Item ID: 646.3001 Accept ***N900040100*** Setup Start ***NS1***
 Revision ID: Stop ***NS2***
 Item Name: Lower Cutter Assy
 Start Date: 9/22/2014 Start Qty: 2.00 ***2*** Cust Item ID:
 Required Date: 9/22/2014 Req'd Qty: 2.00 ***2*** Customer:

APICAL
INDUSTRIES, INC.

ENGINEERING CHANGE NOTICE NO. 02195		SHEET 1 OF 4	
DWG NO. 646.3000	REV: N/C	PREPARED BY S. HUFF	DATE: 01/05/09
DWG TITLE: LOWER CUTTER ASSY		EFFECT ON DWG ☐ INC. ☒ UNINC.	
APPROVED BY: ENGR <i>[Signature]</i>	MFG <i>[Signature]</i>	QC <i>[Signature]</i>	EFF: NEXT ORDER
REASON: REMOVED RIVETS IN FAVOR OF ADDITIONAL SCREWS

SHEET 3 IS:

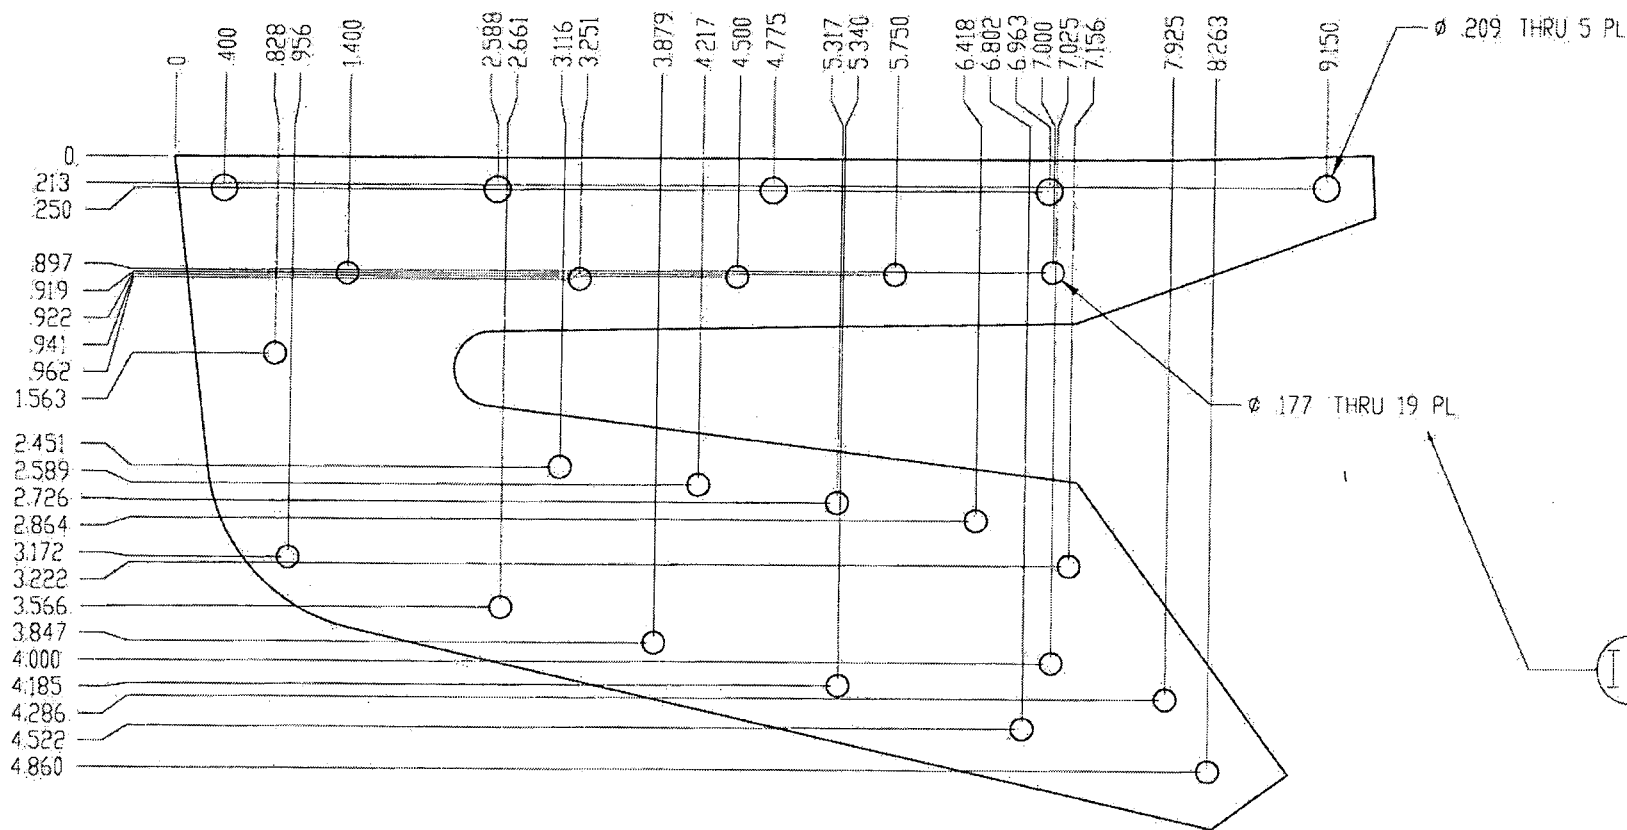
SECTION A-A

SHEET 5 IS:

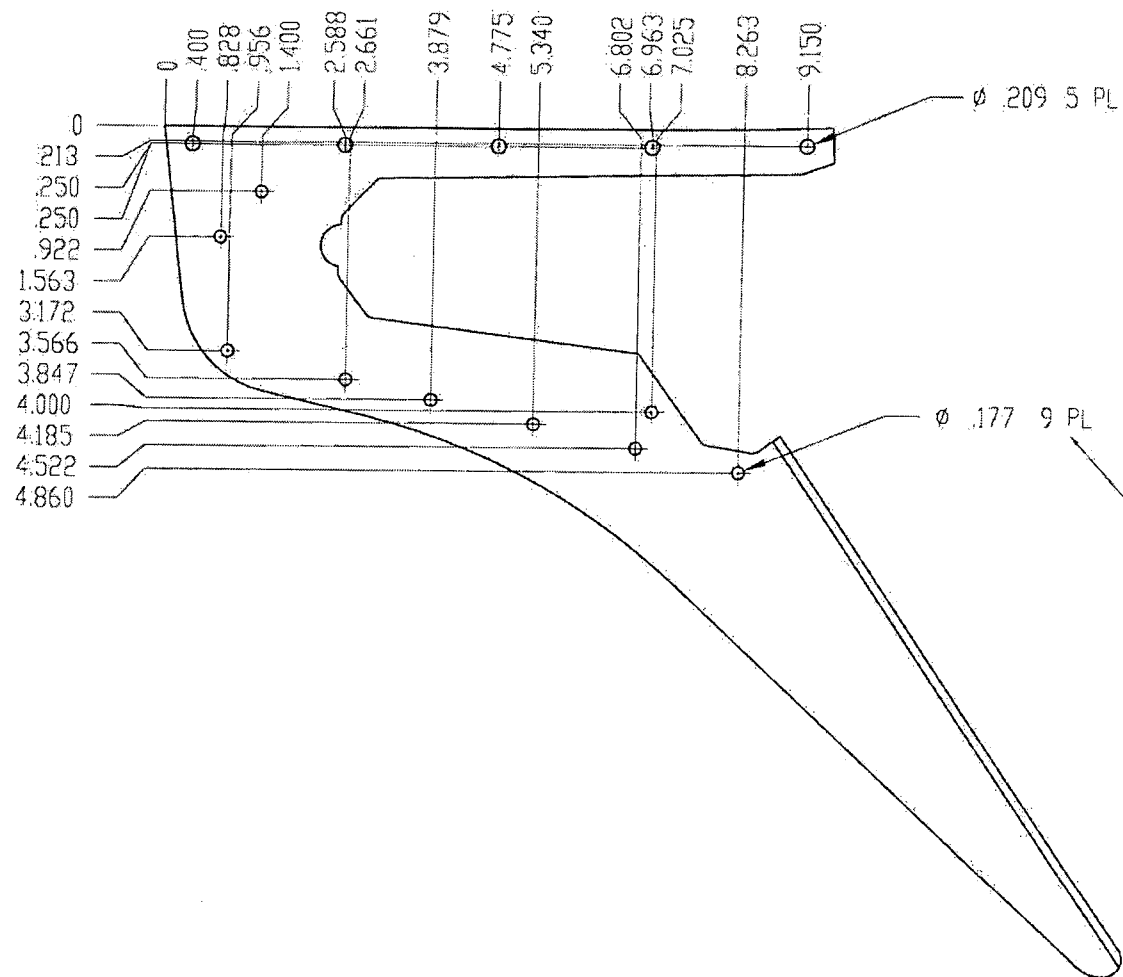
SECTION F-F
